To: T10 SAS Protocol and Phy Working Groups

Subject: SAS-2.1 / SPL: 08-439 An Optical OOB Method

Figure 1 — OOB signal transmission

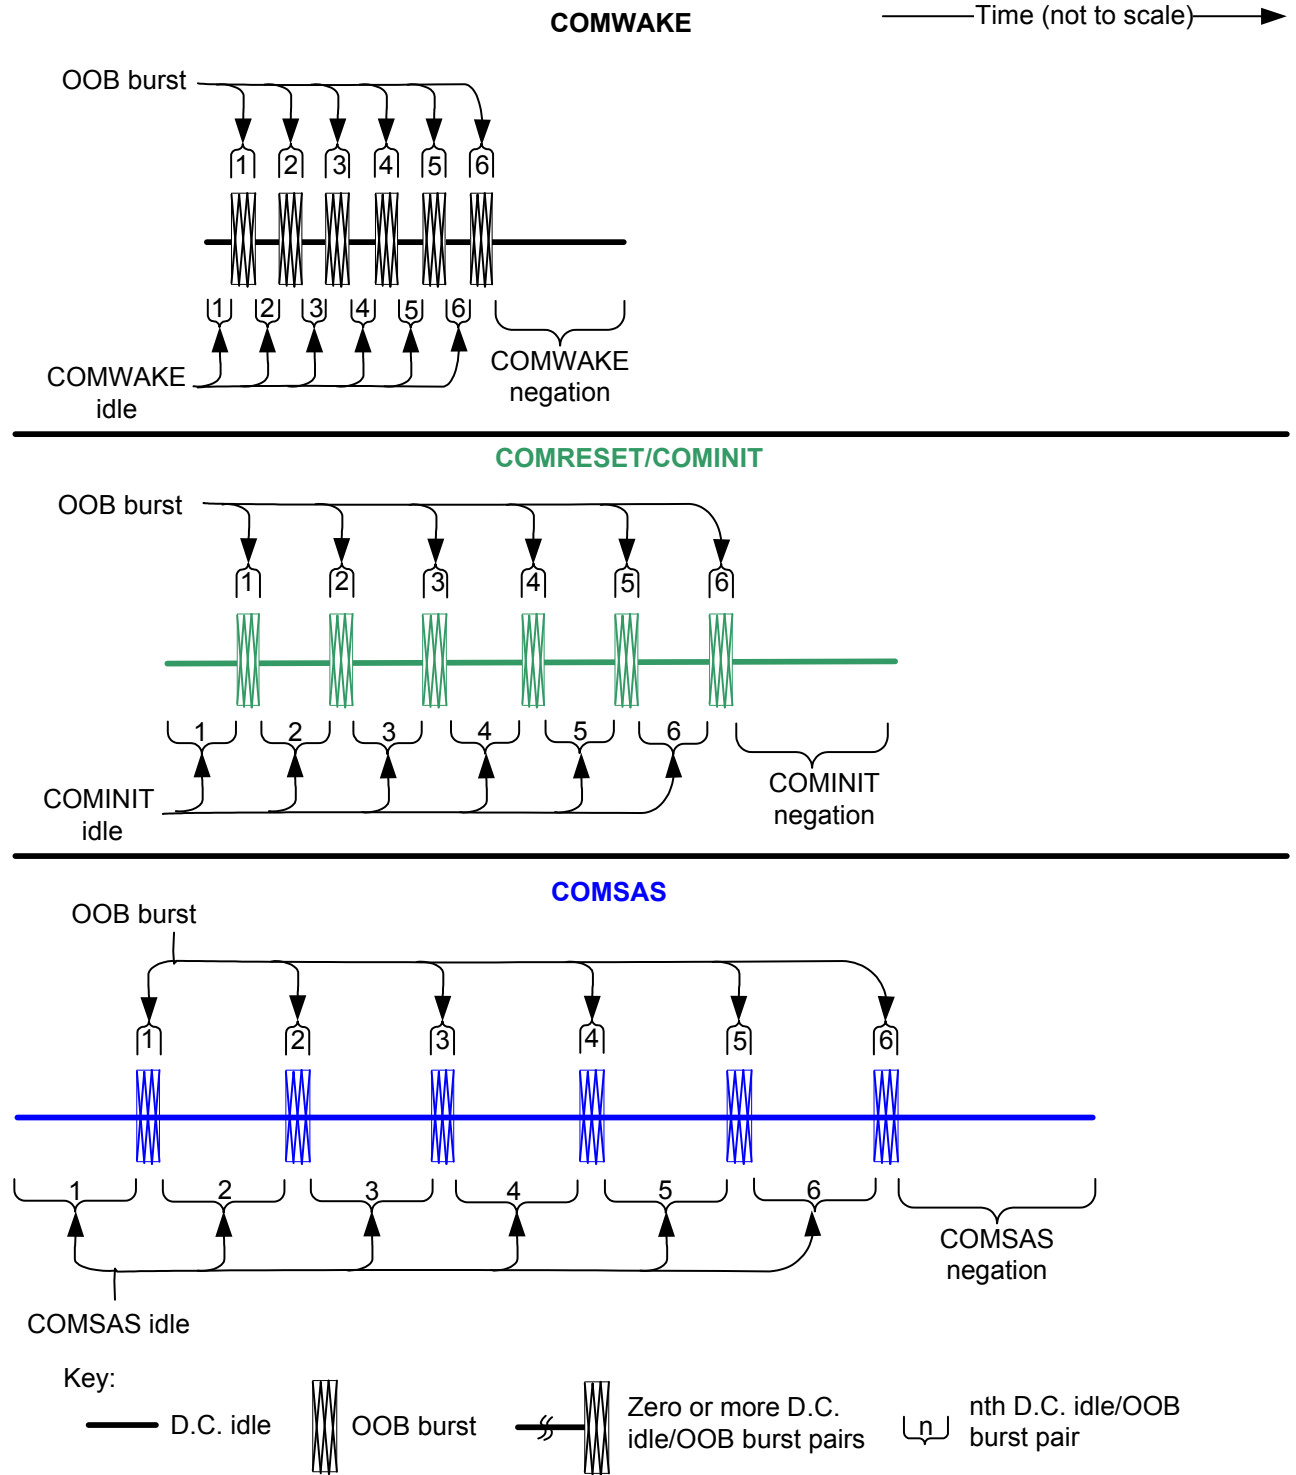
Editor's Note 1: In all of the OOB figured, replace "D.C. Idle" with "OOB Idle".
